Subject: Response to the Abilene Christian University Quality Assurance Program Description
Request for Additional Information

Abilene Christian University
Quality Assurance Program Description
Response to Request for Additional Information

Title: Abilene Christian University Nuclear Energy eXperimental Testing Laboratory (NEXT Lab) Quality Assurance Program Description For Design, Licensing and Construction of the Abilene Christian University Molten Salt Research Reactor

Figure 1-1 ACU NEXT Lab Quality Organization for Design Licensing and Construction

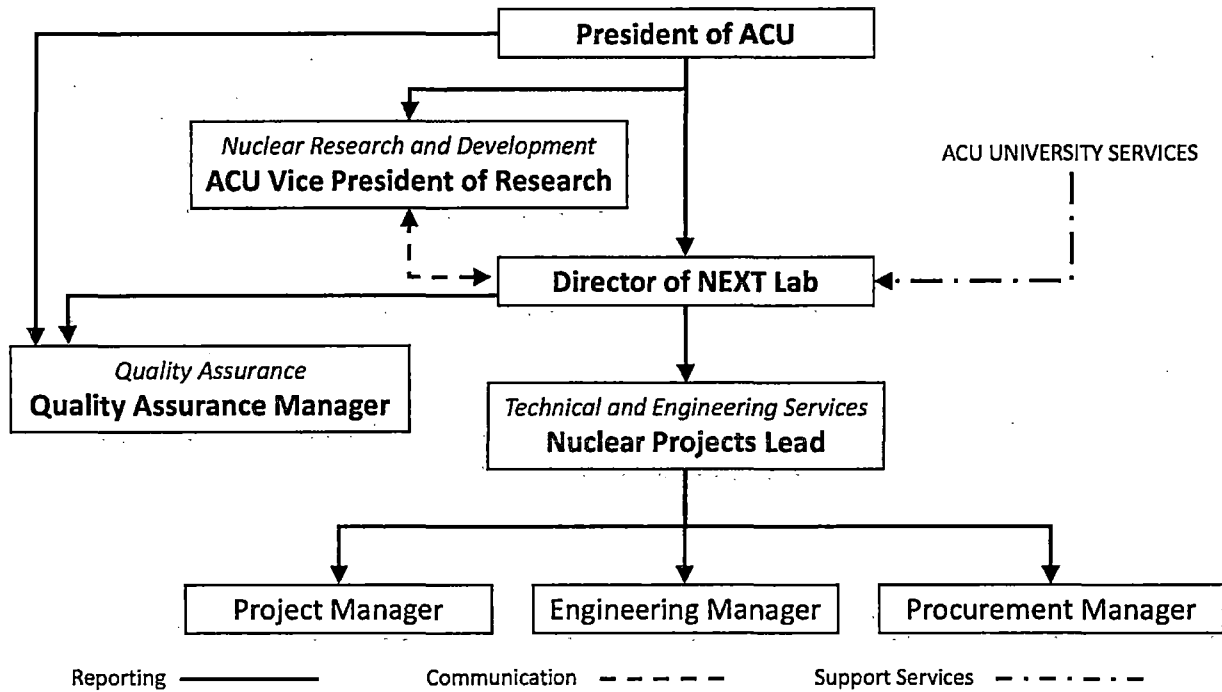
RAI - 1 : *Figure 1-1 in Section 2.1 of ACU's QAPD shows the Nuclear Projects Lead position, but this position does not appear to be described in the QAPD. Clarify where the Nuclear Projects Lead position is described or justify why no additional information is required.*

The "Nuclear Projects Lead" position in Figure 1-1 is described in the QAPD but is incorrectly referenced in the text as "Reactor Project Lead". To address this inconsistency, the five occurrences of "Reactor Project Lead" in Section 2.1 have been corrected to read, "Nuclear Projects Lead".
